# Technical Service Information

## TOYOTA A40 SERIES HARSH 1-2 SHIFT

Figure 1  
AUTOMATIC TRANSMISSION SERVICE GROUP

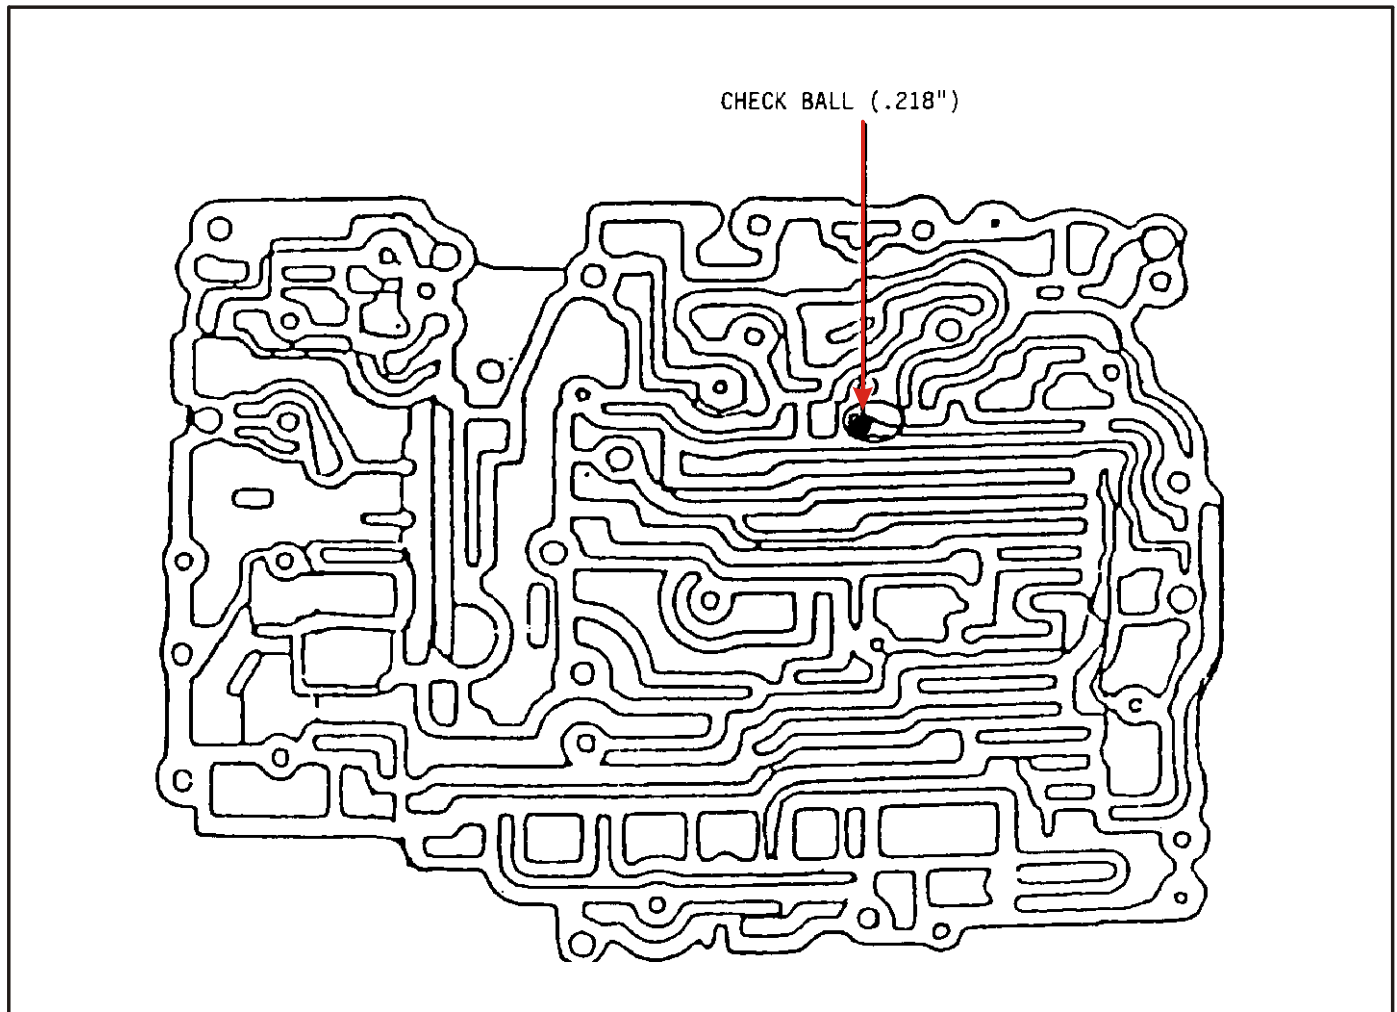
**COMPLAINT:** Harsh 1-2 shift at all throttle positions.

**CAUSE:** Viton check ball missing, or off location.

**CORRECTION:** Install check ball in proper location (See Figure 1)
